Work Order ID 111382

Item Name: Fwd Crosstube - High

DRAWING NO. D212-664-141	TITLE XTUBE ASSY (205/212/412 HI FWD)	REV. D	DART AEROSPACE LTD ENGINEERING ORDER		D.E.O. NO. D212-664-141-D-1	SHEET NO. SHEET 1 OF 2	SCALE NTS
DRAWN	CHECKED	<i>OP</i>	MFG. APPR. <i>ER</i>	APPROVED <i>MP</i>	DE APPR. <i>MP</i>		
DATE 11.04.07	DATE 11.04.11		DATE 11.04.12	DATE 11/04/12	DATE 11.04.12

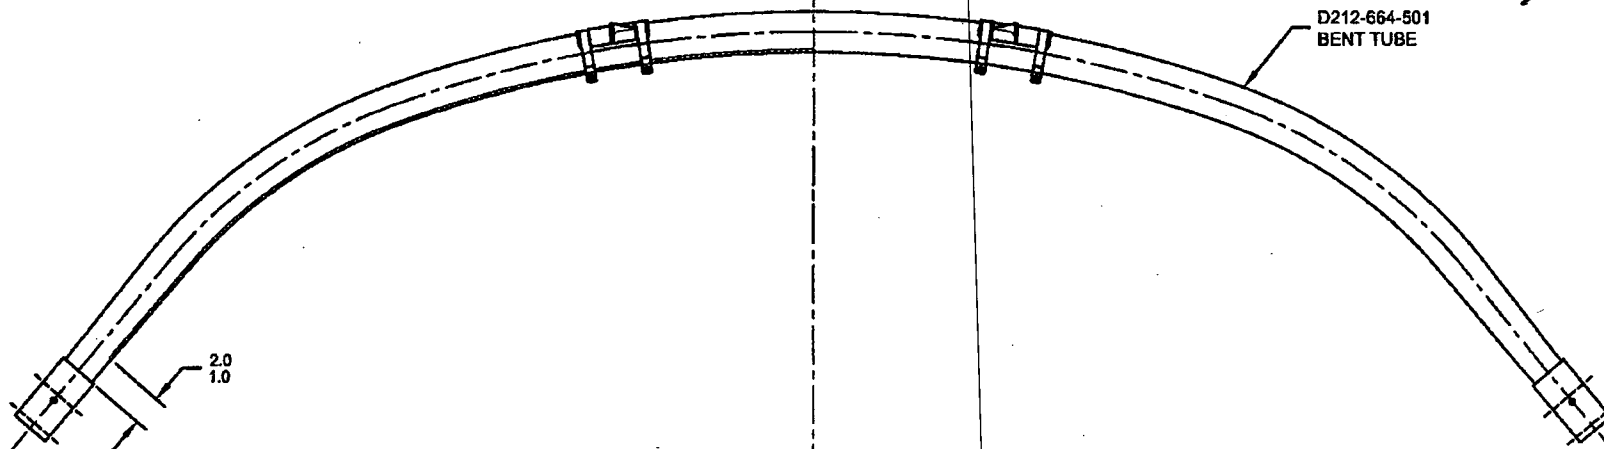
ADD AN INSPECTION WINDOW TO UNDERSIDE OF CROSSTUBE.

NOTES 2 OF SHEET 1 IS AMENDED AS FOLLOWS:

- 2) FINISH: CHEMICAL CONVERSION COAT PER DART QSI 005 4.1
PRIME INSIDE AND OUTSIDE PER DART QSI 005 4.2
MASK UNDERSIDE OF CROSSTUBE AS SHOWN (HATCHED AREA) AND
PAINT OUTSIDE PER DART QSI 005 4.2
REMOVE MASKING AND APPLY CLEAR COAT

**D212-664-141/-141B
ASSEMBLY DETAIL**

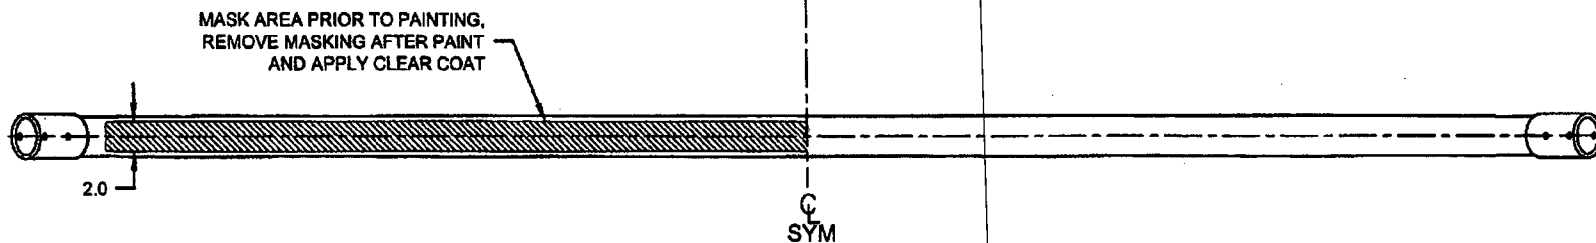
REPLACE MAGNOBOND WITH PROSEAL.

NOTE 12 & 15, SHEET 1 IS AMENDED AS FOLLOWS:

- 12) TO INSTALL D2893-1 SUPPORT: ABRASE MATING SURFACE OF SUPPORT AND CROSSTUBE WITH 180-GRIT SANDPAPER AND REMOVE RESIDUE WITH MEK (OR EQUIVALENT). APPLY A 0.04" TO 0.07" THICK LAYER OF PROSEAL 890 CLASS B-2 (OR AMS-S-8802 CLASS B-2) SEALANT TO MATING SURFACE OF SUPPORT.
- 15) TORQUE CLAMPS 80 TO 100 IN-LB. ENSURE AT LEAST 1.5 THREADS SHOWING IN SAFETY AND THAT NUT HAS NOT BOTTOMED-OUT AFTER TORQUING. PRIOR TO PACKAGING, RE-CHECK TORQUE ON CLAMPS AFTER PROSEAL 890 SEALANT HAS CURED FOR 72 HOURS.
